6.10 Plant and Ventilation

6.10.1 Heating

Figure 6.11R: Proposed Energy Centre Location:

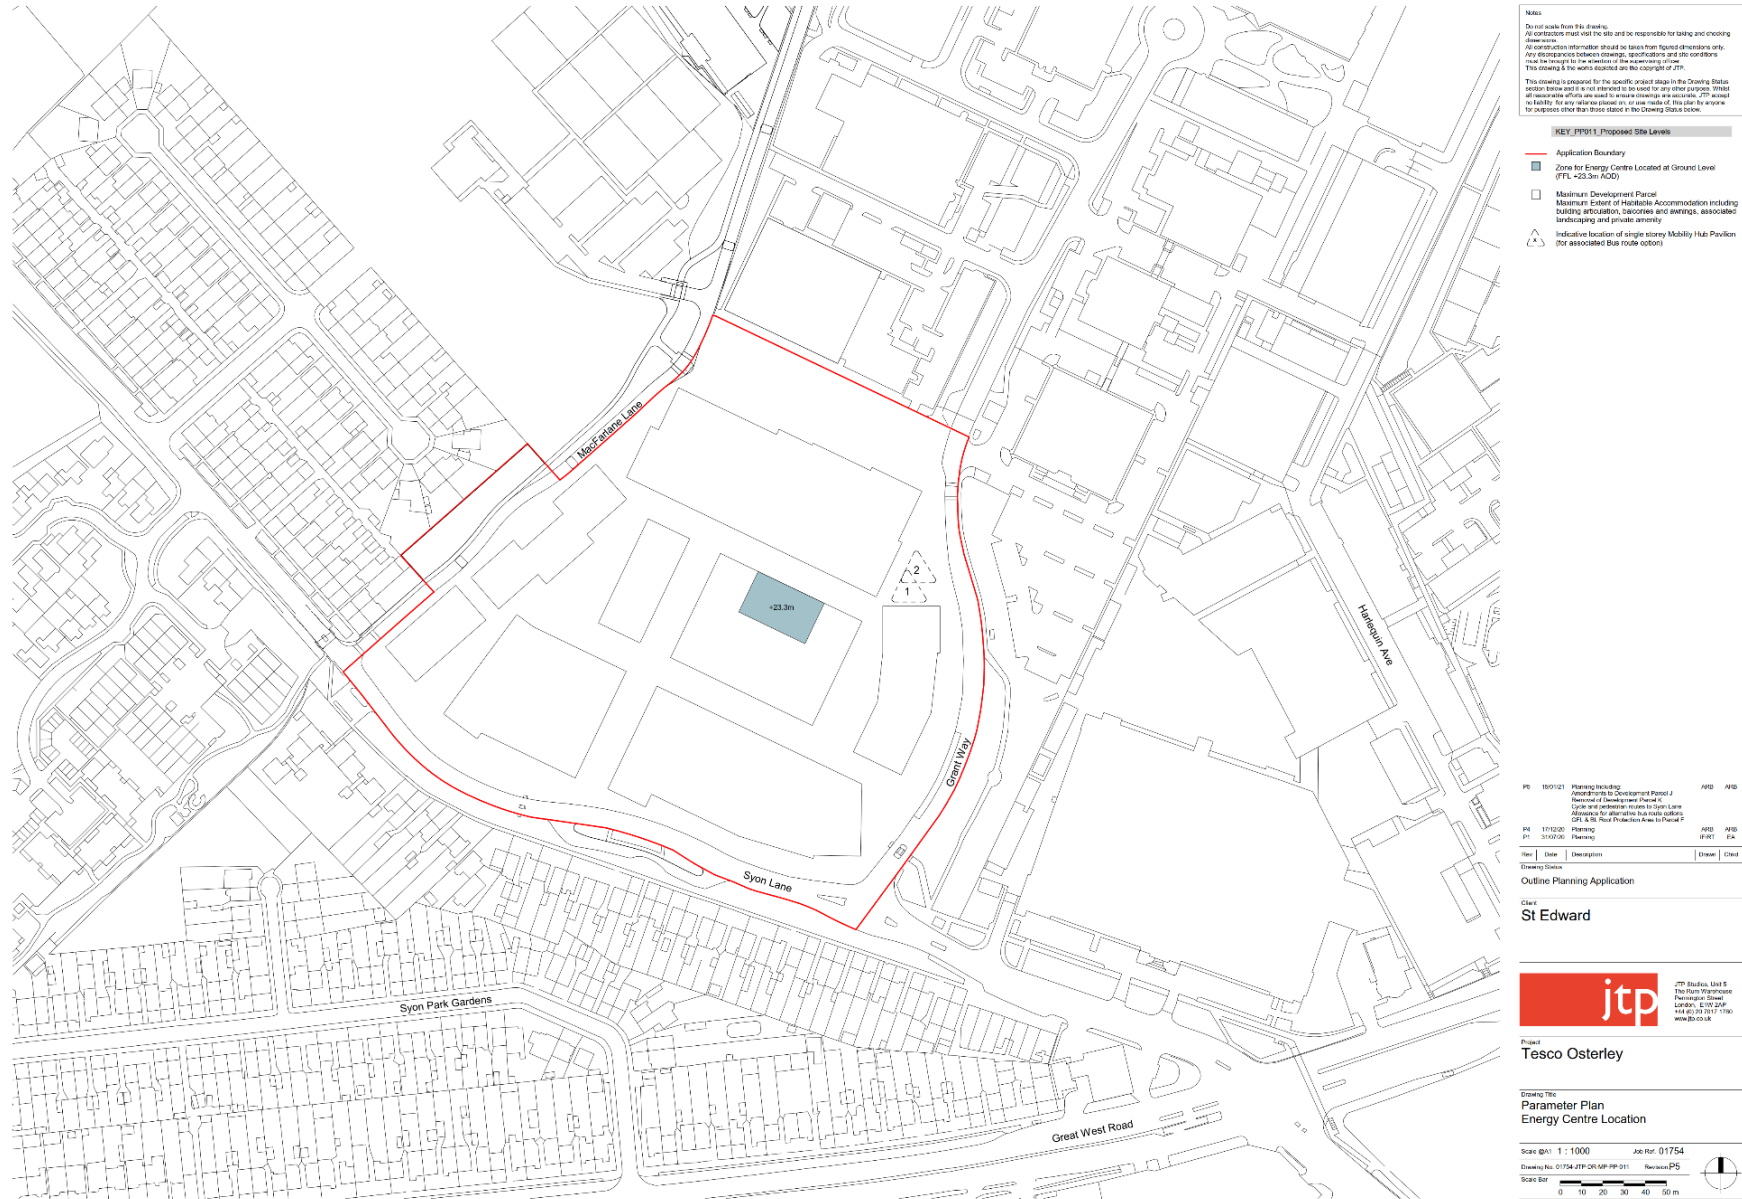
~~Low emission air source heat pumps (ASHP) would be used with gas back-up boilers to provide space heating and hot water. For resilience, the gas boilers would be designed to the full peak capacity of the site. During the RMA stage, options would be explored for the provision of on-site renewable energy. Figure 6.11 shows the zone where which the energy centre would be located at ground level.~~

High temperature low emission air source heat pumps (ASHP) would be used with gas back-up boilers to provide space heating and hot water. For resilience, the gas boilers would be designed to the full peak capacity of the site. During the RMA stage, options would be explored for the provision of on-site renewable energy. The heat pumps would increase water temperature from 30°C to 60°C, enabling 100 % of the heat supply, using electricity as a fuel source. Gas backup boilers would be used only in unplanned circumstances to maintain a heat supply if faults arise. No gas connections would be made to new residential units.

Figure 4.11R shows the zone where which the energy centre would be located at ground level. This located has been chosen due to the requirements and restrictions of the proposed energy centre.
